FIRST FLOOR - AREA (B)
SCALE 1/8" = 1'-0"

COMM. J	MELROSE HIGH SCHOOL	SHEET 7
6909	FOR BOARD OF EDUCATION	
	MEMPHIS CITY SCHOOLS	
	CORNER OF DEADRICK & HAYNES	
DATE 10-9-70	DANIEL T. MCGOWN, A.I.A.	OF 32
	ARCHITECT	
	1503 UNION AVE. MEMPHIS, TENN.

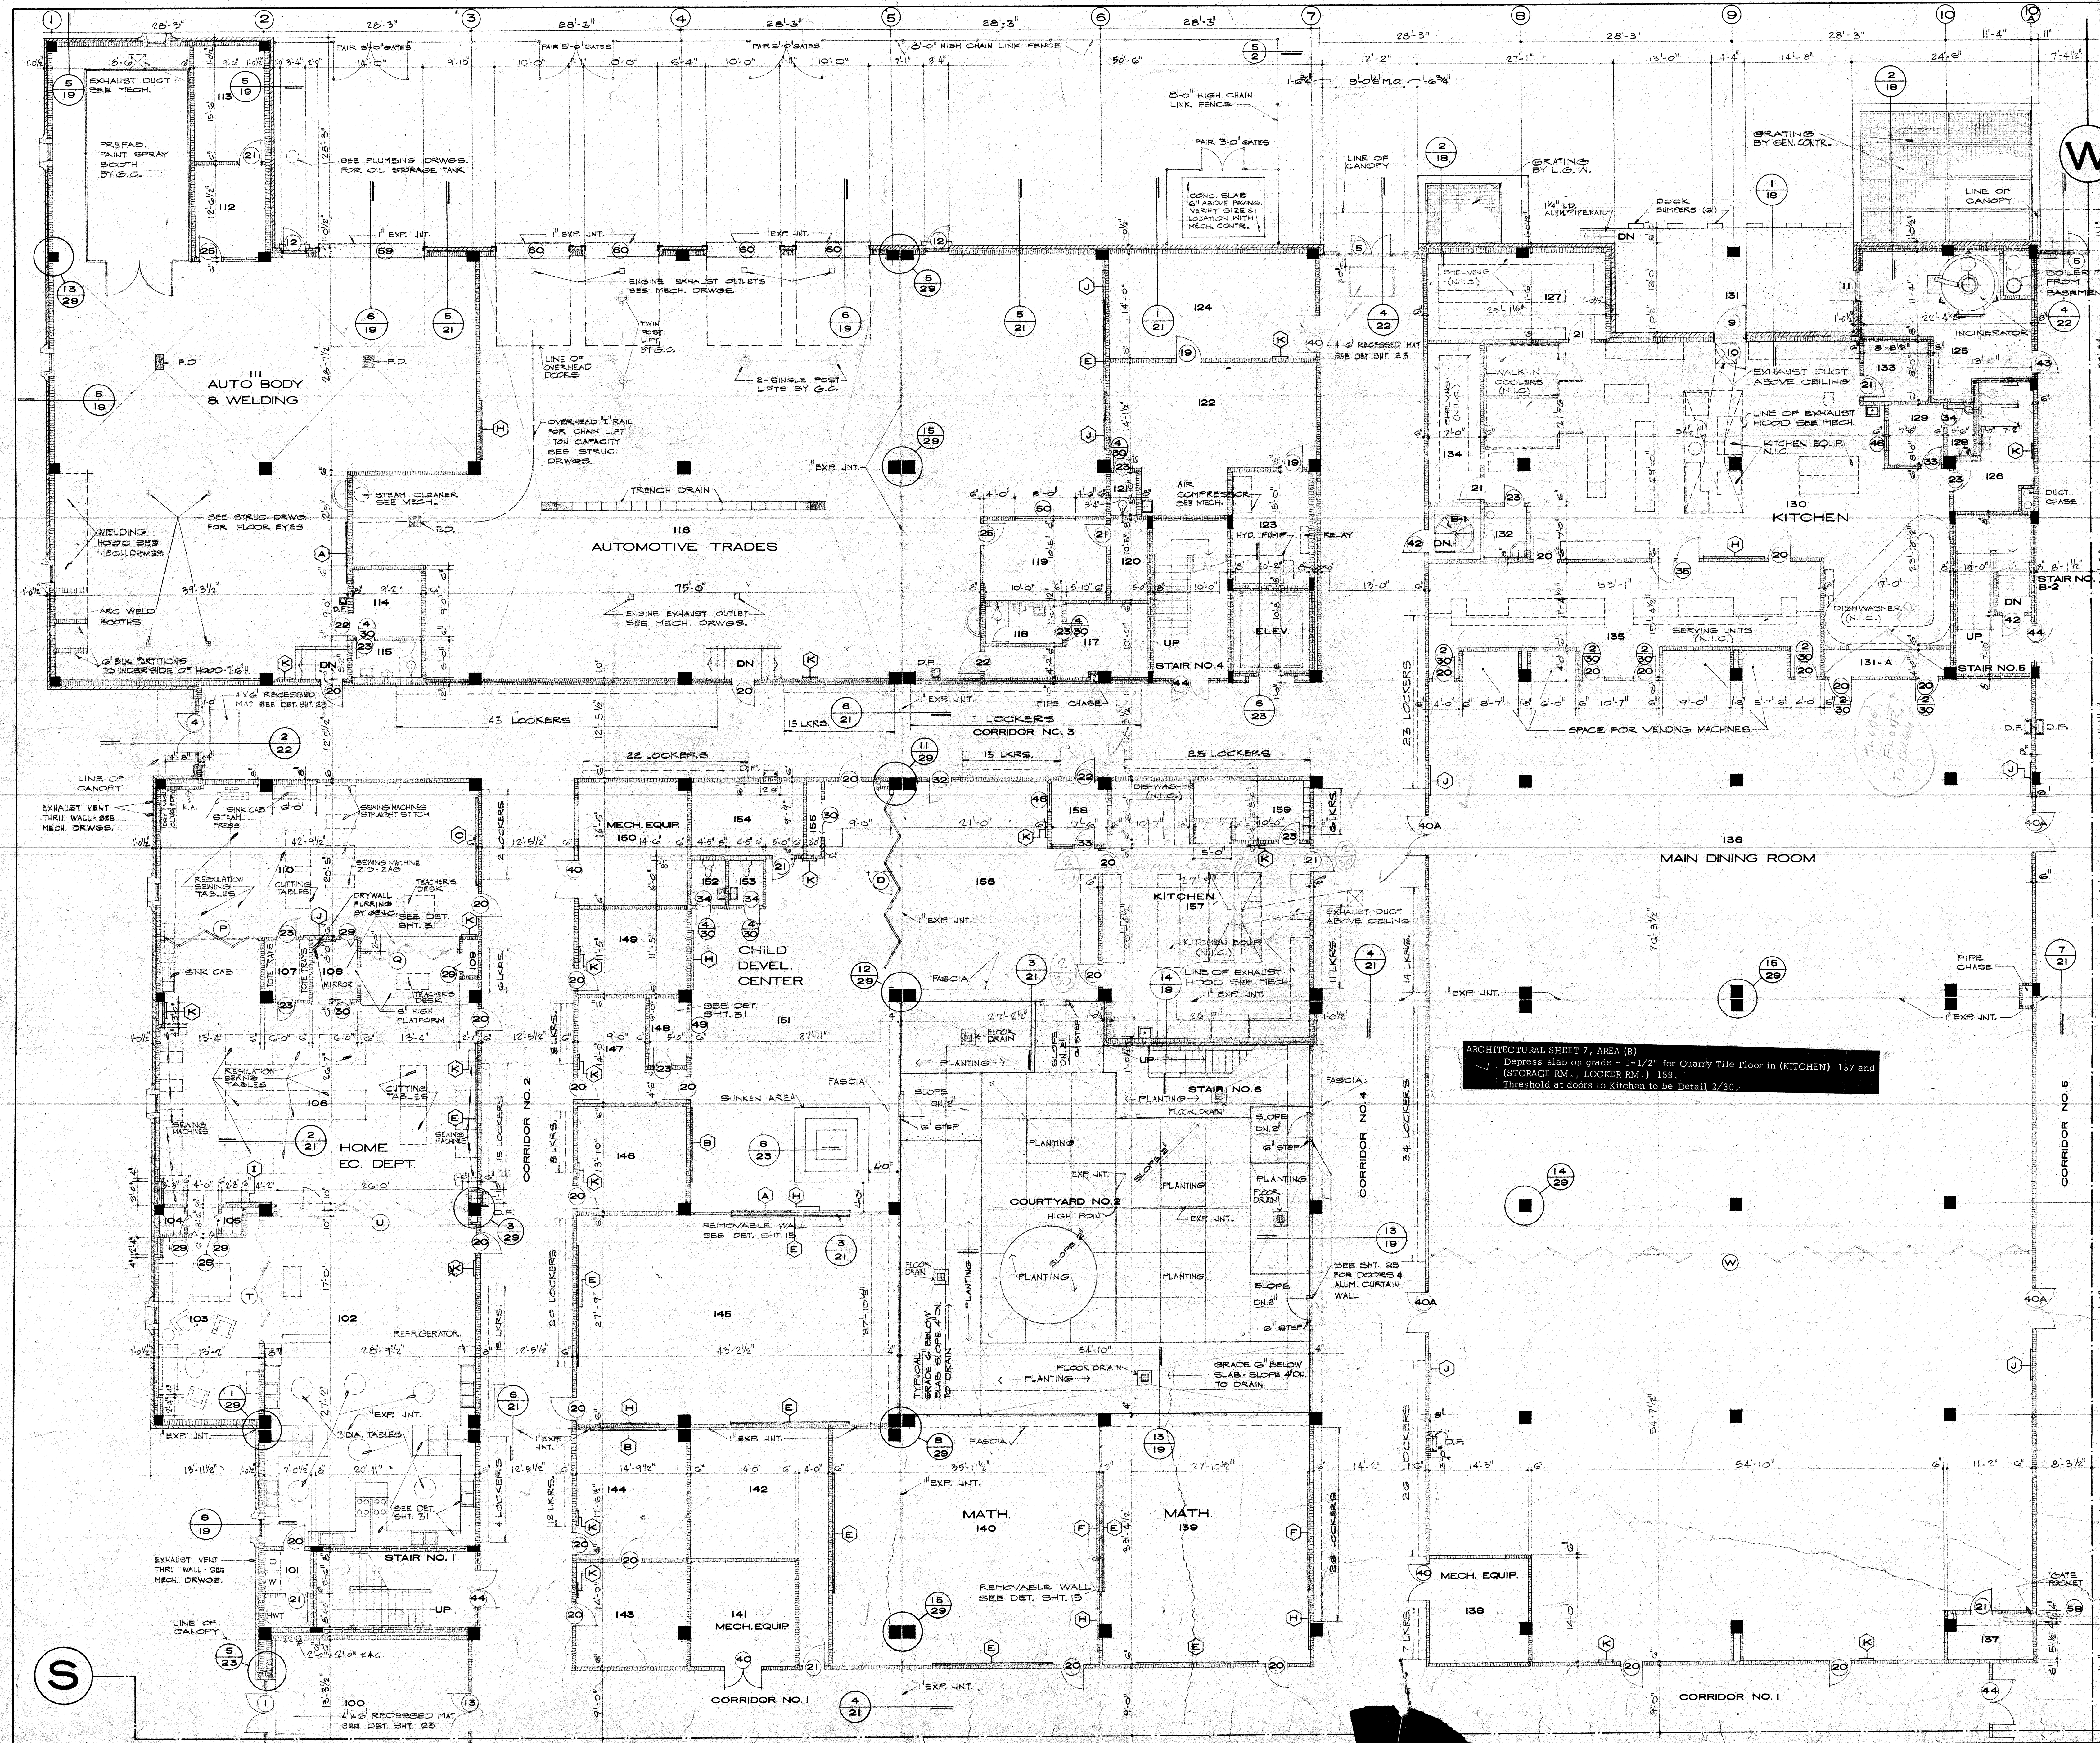
ARCHITECTURAL SHEET 7, AREA (B)
Depress slab on grade - 1-1/2" for Quarry Tile Floor in (KITCHEN) 157 and (STORAGE RM., LOCKER RM.) 159.
Threshold at doors to Kitchen to be Detail 2/30.
